# Access Compliance Report

## Public Rights-of-Way

Intersection ID: 14863	Main Street: WEST_BV	Cross Street: AIRPORT_DR	Location: W
ADA ID: ECE8F013C3C2	Ramp Type: BlendTrans2	Initial Pass/Fail: Fail	Overall Compliance: No
			Severity Score: 33.75

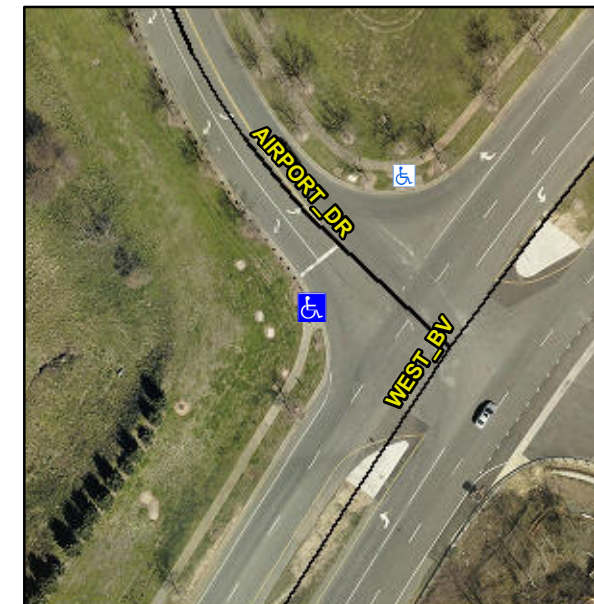
**Not Found, R304.5.1, R304.5.3**

Compliance	Description	Data	Compliance	Description	Data
N/A	Ramp Length (in)	83.0	Yes	BlendTrans Slope (%)	0.0
No	Ramp Width (in)	43.0	No	BlendTrans XSlope (%)	10.3
N/A	Flare Type LT	N/A	N/A	Flare Type RT	N/A
N/A	Flare Slope LT (%)	N/A	N/A	Flare Slope RT (%)	N/A
N/A	Flare Traversable LT?	N/A	N/A	Flare Traversable RT?	N/A
N/A	Landing Length (in)	N/A	N/A	DWS Provided?	N/A
N/A	Landing Width (in)	N/A	N/A	DWS Contrast?	N/A
N/A	Landing Slope (%)	N/A	N/A	DWS Length (in)	N/A
N/A	Landing X Slope (%)	N/A	N/A	DWS Full Width?	N/A
N/A	Landing Curb? (Y/N)	N/A	N/A	DWS Offset (in)	N/A
N/A	Shared Landing?	N/A			
N/A	Gutter Ponding?	N/A	N/A	Gutter Slope (%)	N/A
N/A	Gutter Lip Ht (in)	N/A	N/A	Gutter X Slope (%)	N/A
N/A	Painted X Walk1?	No	N/A	Painted X Walk2?	No
	X Walk 1 Direction	To SE		X Walk 2 Direction	To NE
	X Walk 1 Width (in)	N/A		X Walk 2 Width (in)	N/A
	X Walk 1 Slope (%)	0.1		X Walk 2 Slope (%)	0.6
	X Walk 1 X Slope (%)	4.1		X Walk 2 X Slope (%)	7.7

N/A	Ramp inside XWalk1?	N/A	N/A	Ramp inside XWalk2?	N/A
	Road Slope (%)	8.0		Clear Space?	N/A
	Road X Slope (%)	1.7	N/A	Clear Space to XWalk (in)	N/A
N/A	Any Obstructions?	N/A	N/A	Storm Grate/Utility Hazard?	N/A
	Obstruction Type			Storm Grate/Utility Type	
		N/A			N/A
			Yes	Surface Condition? (G/P)	Good
			No	Curb Slope (%)	24.3

**Remove & Replace Curb Ramp With Two New Directional Ramps or Equivalent.**
